Final Report

Taro East Landfill Expert Panel

October 2000

Figure 1
Chloride Concentration For West Landfill Leachate

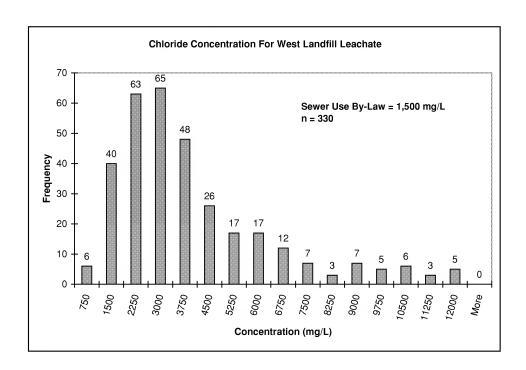
Chloride concentration limits for Taro West are included in the compliance agreement, which limited chloride concentration to a "not to exceed value" of 42,678 mg/L which is well above the standard By-Law limit of 1,500 mg/L, pending construction of a pretreatment plant for chloride removal. Average Taro West Landfill chloride concentration is about 4,000 mg/L and the distribution of concentration is shown in Figure 1.

Figure 2
Chloride Concentration for East Landfill Leachate

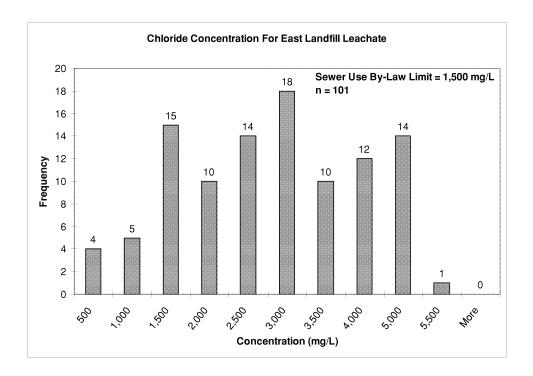
It is evident that the leachate from Taro East does not meet the Hamilton By-Law for chloride (or sulphate) concentration. Nor has a "compliance agreement" been established for Taro East as has been done for Taro West. Figure 2 shows the distribution of chloride concentration results reported by Taro for the East Landfill leachate.

Chloride in the leachate is an issue because the Hamilton-Wentworth Sewer Use By-Law limits chloride to a maximum of 1500 mg/L, a level which is usually exceeded in East Landfill leachate (see Figure 2) as well as the other leachates mentioned earlier, including the West landfill.

- 6. The Panel recommends that any discharge of East Landfill leachate should be subject to the following conditions:
 - a) The impact of the Taro West and East Landfill leachate on the Woodward Avenue WWTP should be evaluated through experimental wastewater treatment pilot plant tests together with scans for metals and trace organics removals and accumulation in biosolids. Discharging of East leachate to the Woodward WWTP should only occur if these tests show that is acceptable.

- b) In lieu of a chloride removal pre-treatment plant (and given savings realized by not building the plant and by eliminating the trucking and handling of leachate off-site), the Company should provide funding (to be negotiated with the Region) for using the sewer system.

8.3.5.2 Groundwater Degradation Caused by Taro Landfills

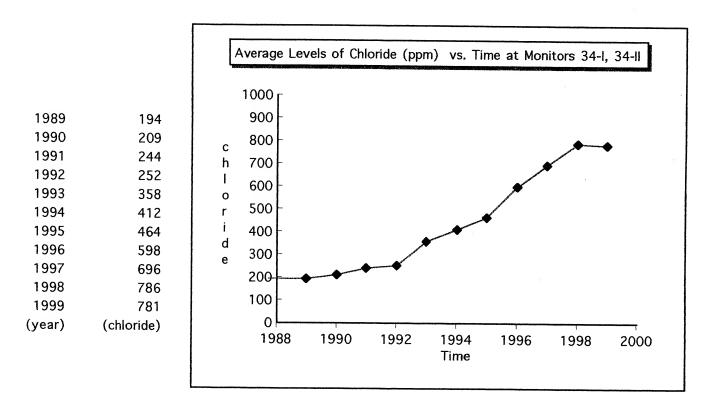
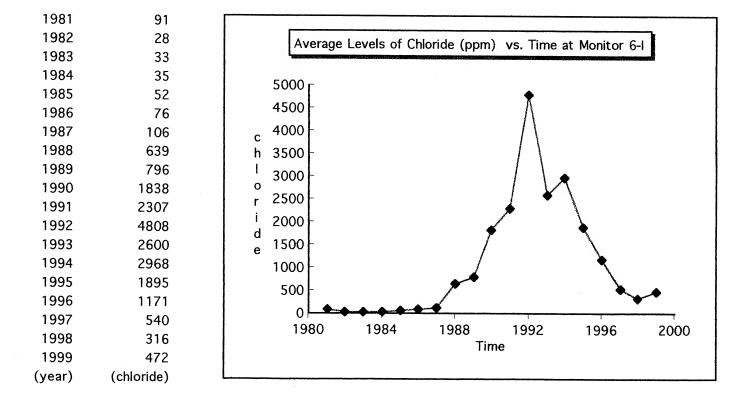
There is no sign that any leachate contamination from the East Landfill has reached the groundwater flow system beneath or downgradient of the landfill. The leachate barrier and collection system are functioning as designed, and are containing the East Landfill's leachate.

Leachate from the West Landfill has caused groundwater contamination, and mitigation measures (containment wells) are in place and have been used to try to keep the zone of leachate contamination confined to the immediate area of the landfill. Nonetheless, degraded groundwater has been moving northwards from the area of the Taro East and West landfills since at least the early 1990s. It is characterized by a significant rise in levels of chloride and other inorganic parameters in groundwater downgradient (to the north) of the landfills. Areas closest to the landfills generally saw levels peak in the 1992 to 1994 period, with a significant reduction in the magnitude of the degradation since then.

- c) The Company should install at least two additional nests of monitoring wells between the Taro landfills and the Niagara Escarpment, at locations to be determined in consultation with the CLC. These wells should be added to the regular groundwater monitoring program for the landfills.

Figure 5
Total Suspended Particulate - % exceedances (samples)

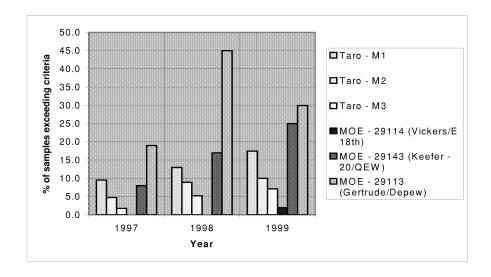
Table 4 and Figure 5 do indicate that there have been more exceedances of the 24-hour criteria at Taro than at Vickers and 18th. This can be attributed to the quarrying and material handling operations at the site. Similar major construction sources are not present around the Vicker's station. These exceedances are significantly below the percentage of exceedances at the other two sites.

- 1. Add fine particulate monitors to the air quality monitoring program. Specifically, PM2.5 monitoring should be included.
- 2. The design of an appropriate network and approach for air quality monitoring should be developed in consultation with the CLC.
- 3. Consideration should be given to locating a PM2.5 monitor within the nearby community to demonstrate the differences in dust levels measured at the property boundary of the site and within the community. This monitor could be located in different areas for six month to one year periods to determine particulate levels in specific locations.

Figure 6 Volatile Organic Compounds

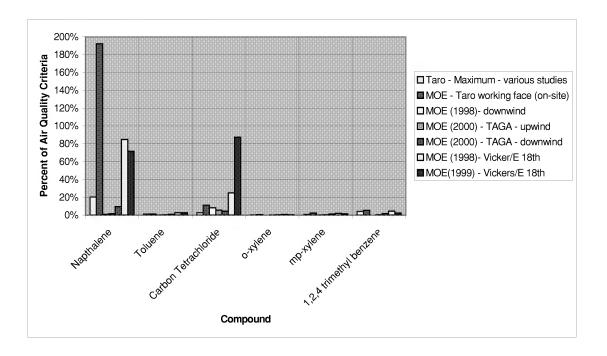
Modifications to the Leachate Extraction Procedure will provide more detail and control over VOCs in the waste and should provide a better understanding of possible emissions, but new volatile organic compounds can be formed in the landfill at any point in its life.

- 1. VOC monitoring by the Company should be continued annually.
- 2. The VOC monitoring should include a full (open) analytical scan to identify any changes to VOC emissions. This would be done by performing a full analytical scan and compound identification using a gas chromotagraphy mass spectrometry analysis. This should be done by a certified laboratory familiar with this type of analysis.
